REMARKS

Applicants have submitted amended drawings in response to the Notice of Omitted Items in a Nonprovisional Application, dated May 17, 2004, and the subsequent Notice of Non-Compliant Amendment, dated August 20, 2004. The enclosed replacement drawings are labeled with "Replacement Sheet" in accordance with 37 CFR 1.84. Annotated copies of each drawing showing the changes are labeled "Annotated Marked-up Drawings" are also included. Applicants believe that the enclosed drawings meet the requirements of an amended document as set forth in 37 CFR 1.121.

In the drawings:

Fig. 1

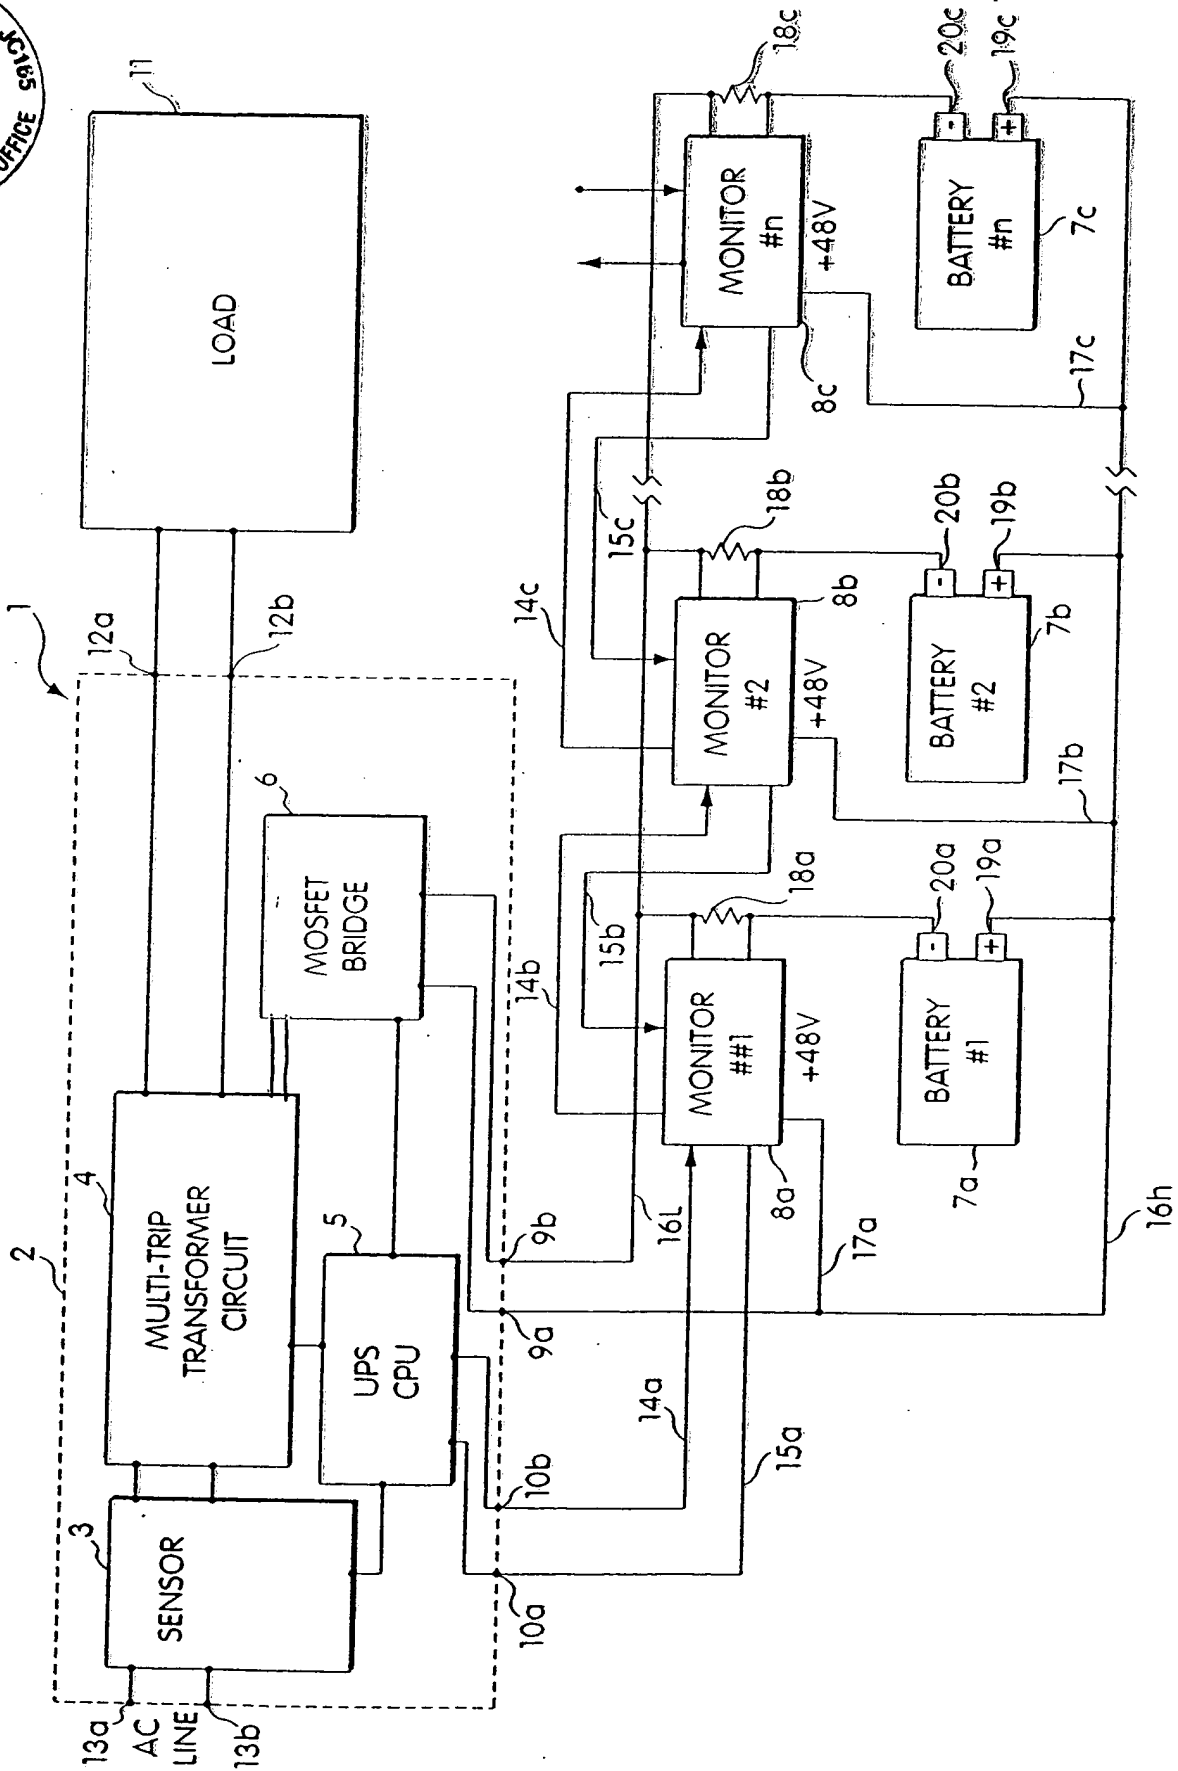
In FIG. 1, add two connections from MOSFET bridge 6 to multi-trip transformer circuit 4 as shown in red ink.

Fig. 3

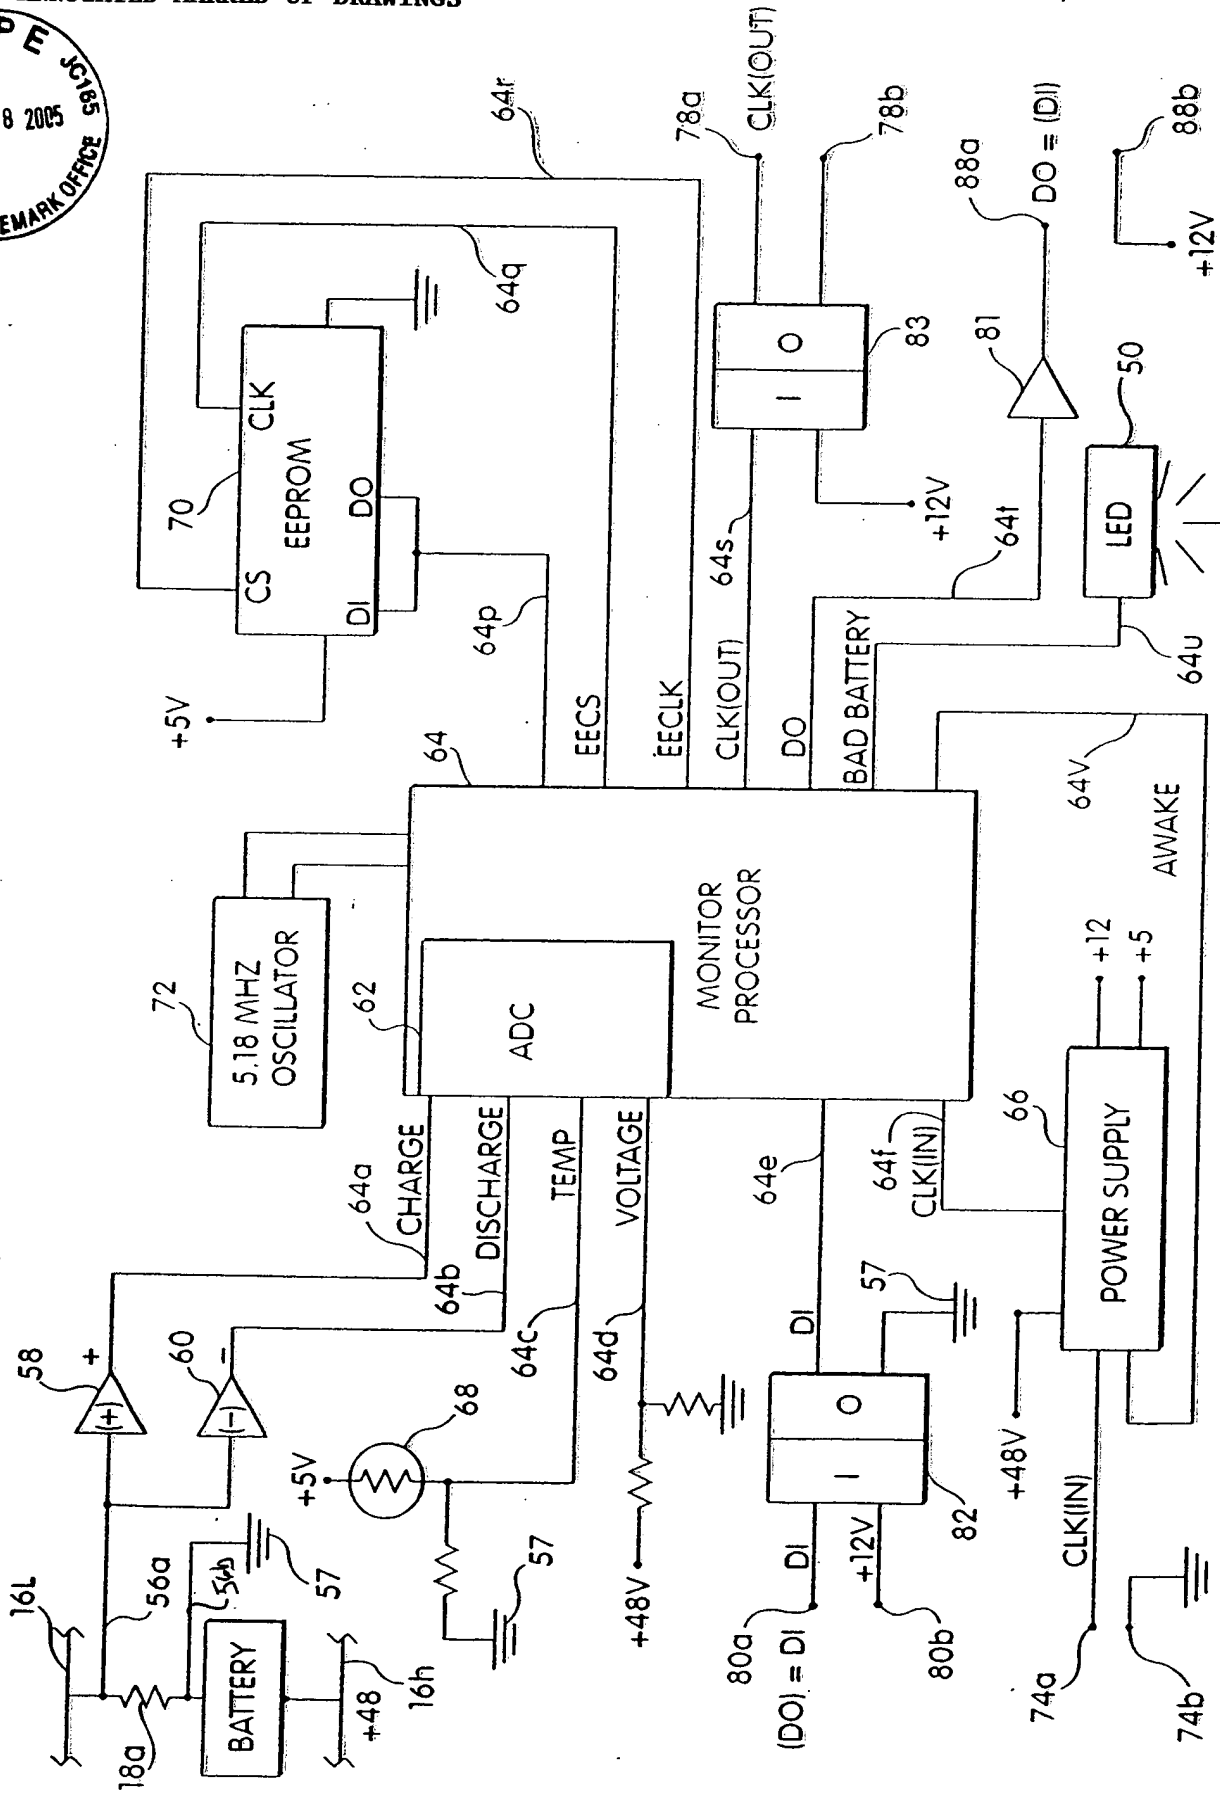
In FIG. 3, add reference designator 56b and accompanying lead line as shown in red ink.
